883 CYLINDER LINER CHANGE

Purpose

Figure 1. Earlier 883 Cylinder with Steel Cylinder Liner

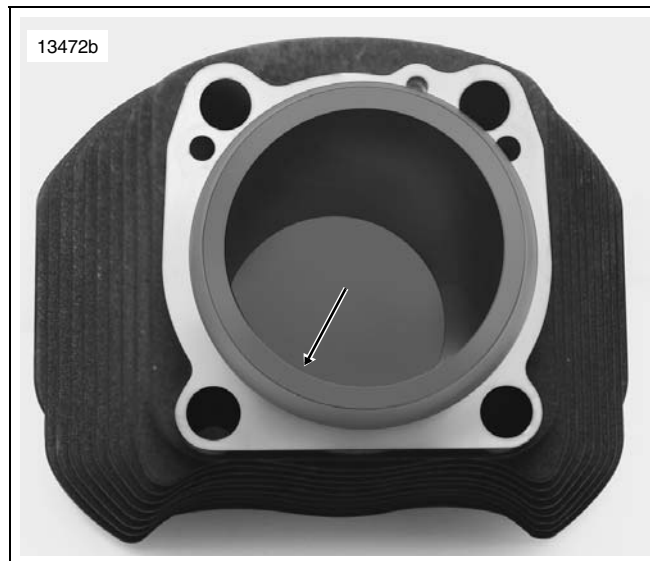
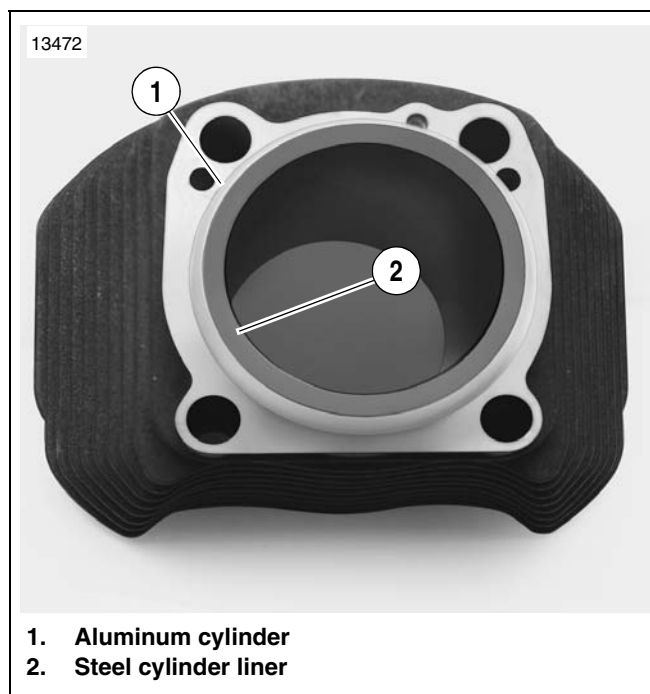
The purpose of this bulletin is to inform dealers and technicians that XL 883 cylinders can no longer be bored out to fit 1200 pistons. The 883 cylinder changed to a thinner liner which does not allow for boring to accommodate 1200 pistons.

If a customer chooses to convert an 883cc Sportster to 1200cc displacement by boring existing cylinders, first inspect the 883 cylinders to determine if they allow adequate liner thickness to be bored. See Figure 1. Earlier cylinders have a full steel liner extending from the base. See Figure 2. Later cylinders have an aluminum portion extending from the base with a steel insert.

- The new cylinders may be bored and fitted for oversized 883 pistons listed in the parts catalog.
- If you attempt to bore a later 883 cylinder to 1200, enough material will be removed from the steel cylinder liner to render the cylinder unserviceable. The thinner cylinder liner does not allow for boring to accommodate the 1200 piston.
